Project Name: South Sound Village Cooperative File #: 19-2860

Concept Review: 9/2019 Detail Review: 9/2020

Checklist filled out by Nicole Floyd, Senior Planner

CITY OF OLYMPIA MULTI-FAMILY RESIDENTIAL Chapter 18.170

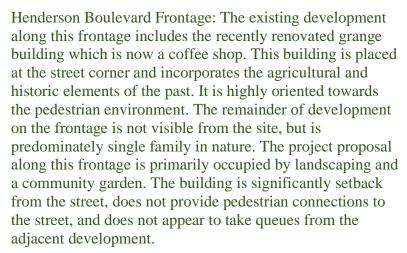
Detail Staff Analysis: The Henderson Boulevard street frontage has been significantly enhanced to better emphasize this side of the building as a building frontage. A clearly defined walkway and courtyard area has been defined. The design does not specify how this will be used as the primary building entry. It appears to be a private entry rather than main building entry. Staff encourage the board to consider how the applicant intends to use this area.

Detail Applicant Response: Henderson has been selected as the primary frontage. Pedestrian access is provided via a concrete paved walkway starting near the Henderson/Yelm intersection leading up to the building entrance at the patio. The large tree located in the courtyard was moved south to enhance the sightline between the Henderson crosswalk and entry door. The larger massing defined by the higher roof and stone façade with the prefinished white aluminum pergola structure provide visual cues to identify the building entrance location. Additional note, roof canopies have been added to the exterior doors on Yelm to enhance the pedestrian access along this frontage as well.
